Operational Waste Management Plan

FOR OCCUPATION CERTIFICATE APPROVAL

Nihon University
9 Church Street, Newcastle

Date	21.07.2021
Project No.	17-0347
Issue	F
Form	A400

Figure 3: Site Plan illustrating proposed collection point and bin route path - Refer to A035 [Extract Above]

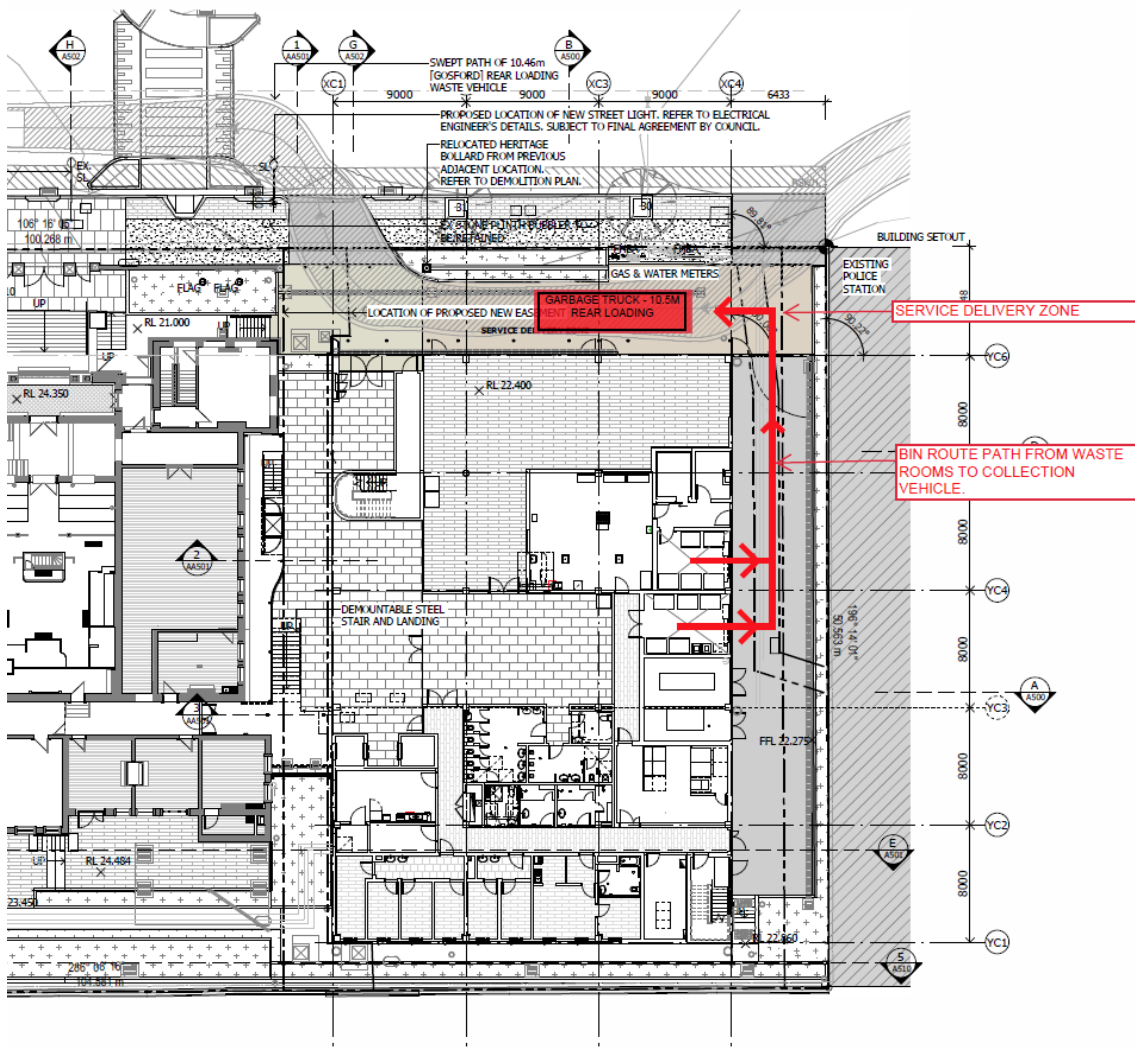
The Services Delivery Zone has been designed as follows:

- The zone and access driveways are designed in accordance with “Australian Standard 2890.2 Parking Facilities – Off-Street Commercial Vehicle Facilities – 2002”.
- The zone has an unobstructed head clearance, suitable for the 10.5m Rear Loading Waste Vehicle.
- At time of collection, the bins will be wheeled from the waste rooms, along the adjacent hardstand to the Services Delivery Zone, by either the building manager or Private Commercial Waste contractor. A motorised bin hopper can be supplied and used by the private waste contractor to assist in the safe movement of the MGBs from the Waste rooms to the Service Delivery Zone.
- The path of travel from the bin room to the point of collection is a step free access and a suitable gradient for the maneuverability of the bins.
- The below *Figure 3* below illustrates the proposed collection point and bin route path.

Extract from amended drawing A-108:

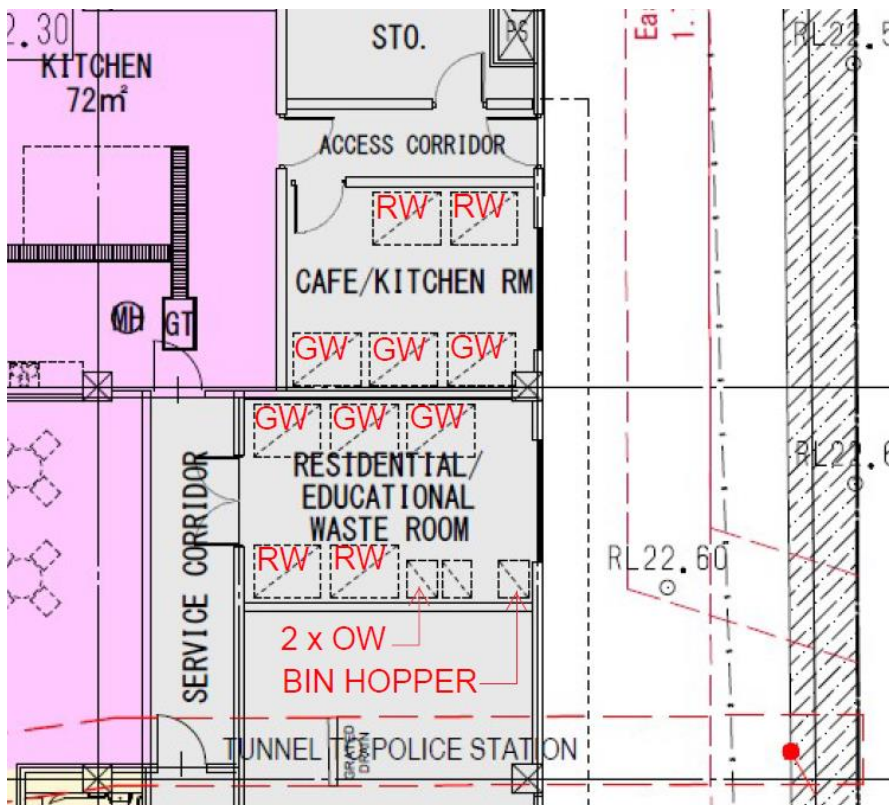
The design of each of the Waste Storage rooms have been amended as follows:

Please refer to updated drawing A-108, Rev 1 with amendments to the layout and configuration of the waste rooms as indicated above.
